# MACARTHUR TRANSIT VILLAGE PROJECT

Volume 4. Response to Comments Document  
SCH No. 2006022075

Prepared for:  
City of Oakland

## **NOTICE OF AVAILABILITY OF FINAL ENVIRONMENTAL IMPACT REPORT FOR THE MACARTHUR TRANSIT VILLAGE DEVELOPMENT PROJECT**

FIGURE III-10

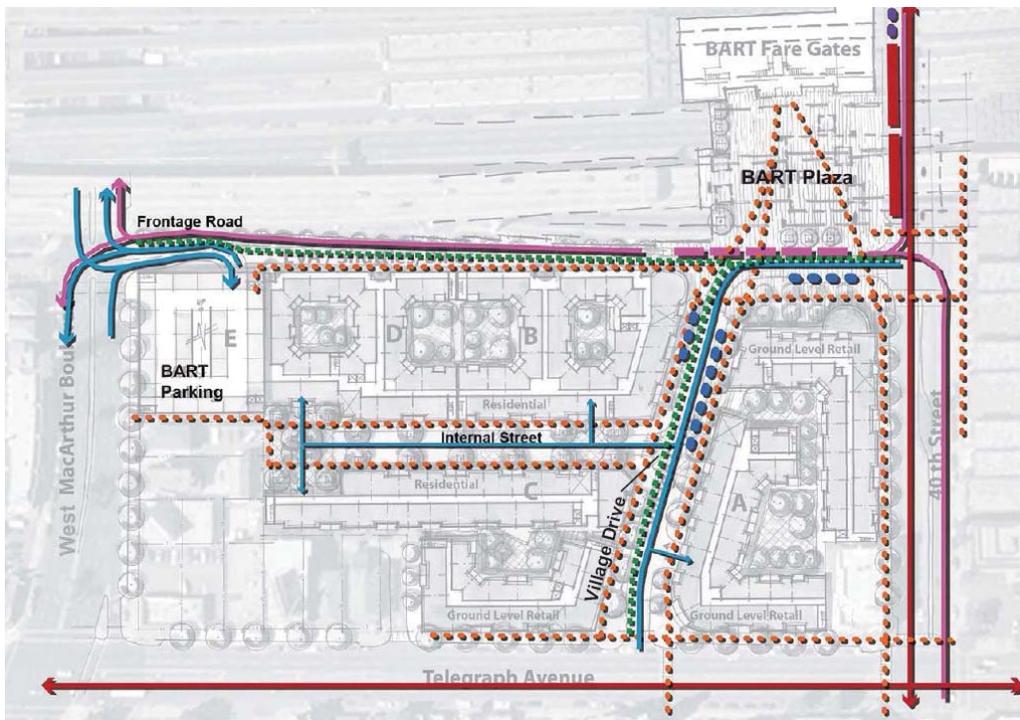
**MacArthur Transit Village Project – Proposed Circulation Plan**

Response B16-4: The conceptual site plan and on-site circulation and access illustrated in Figure III-10 has been reviewed based on the significance criteria detailed in the EIR and no significant impacts were identified. The proposed project will provide significant improvements for pedestrians, bicyclists, and shuttles along Frontage Road (labeled as Entry Drive on exhibits included in comment) over current conditions. Two-way circulation will be permitted along short segments of Frontage Road, but the majority of its length will be reserved for

**Figure 1: Modeled annual average concentrations of PM 2.5 from freeway sources at the Macarthur Transit Village**

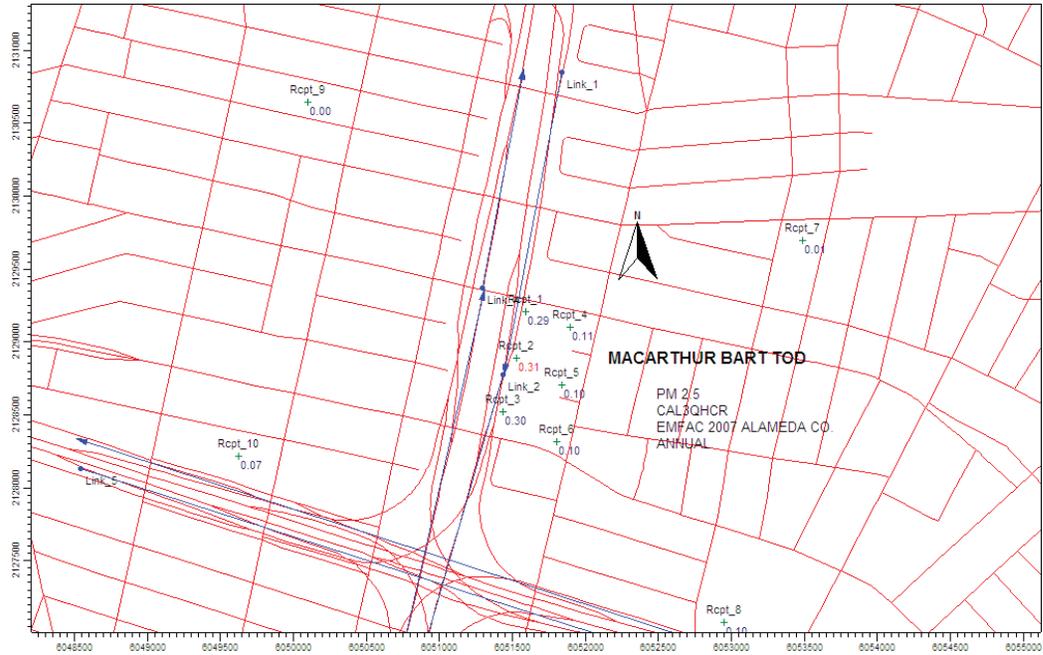
Figure 1 (attached below) illustrates estimated annual average freeway contributions to PM 2.5 concentrations at the Mac Arthur Bart Transit Village project site. Based upon the CAL3QHCR Line Source Dispersion Model Version 2.0, the maximum annual average contribution to PM 2.5 concentrations of from vehicles on major roadways at the project site was 0.31 micrograms per cubic meter. Figure 2 reflects the highest 24 hour concentration from freeway sources.

There is no established health based no effect level for PM 2.5 exposure and both EPA and CARB have acknowledged that health effects occur below current state and federal thresholds for PM. Based upon recent study in Los Angeles, a 0.1 ug /m3 change in PM2.5 results in a 0.14% increase in non-injury mortality or an increase of about one excess death per 100,000 persons per year (Jerrett 2005). Similarly, based upon Concentration Response Functions in the 2002 CARB Staff Report on AAQS for PM a 0.1 ug /m3 increase in PM2.5 affecting a population of 100,000 adults would result in about 1 extra premature death per year. The same increase would result in ~80 days per year with respiratory symptoms, 108 days with work limitations, and 577 days with minor activity limitations in the same adult population.
